# APPLICATION FOR MODIFICATION ASSESSMENT REPORT

Application Number:	Mod2023/0268		
Responsible Officer:	Thomas Prosser		
Land to be developed (Address):	Lot 17 DP 8595, 121 Pacific Road PALM BEACH NSW 2108		
Proposed Development:	Modification of Development Consent DA2021/2364 granted for Demolition works and construction of a dwelling house including a swimming pool and cabana		
Zoning:	C4 Environmental Living		
Development Permissible:	Yes		
Existing Use Rights:	No		
Consent Authority:	Northern Beaches Council		
Land and Environment Court Action:	No		
Owner:	Kede Peter Carboni		
Applicant:	Kede Peter Carboni

Photo 1: View over the rear of the site from neighbouring property

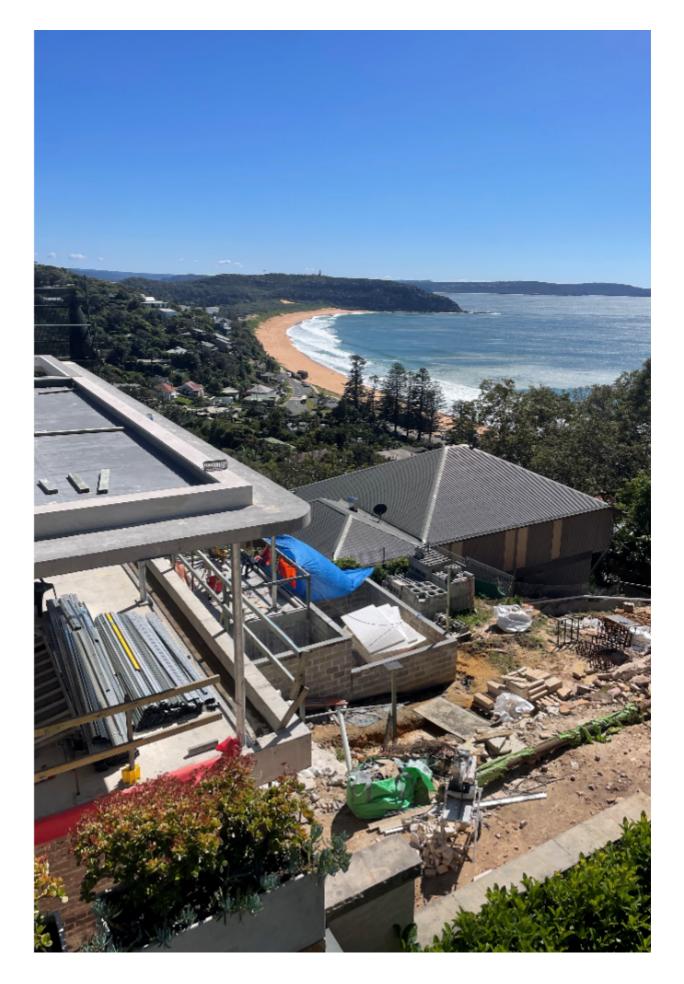
The site has extensive views toward palm beach and Barrenjoey lighthouse.

The views are obtained form living rooms and bedrooms at the side of the property, from sitting and standing position.

The view toward the beach will be maintained as the proposed stairs are below this view corridor. The impact is therefore negligible.

The stairs comply with all built form controls under the DCP and have a negligible impact on views. The view sharing is therefore reasonable.
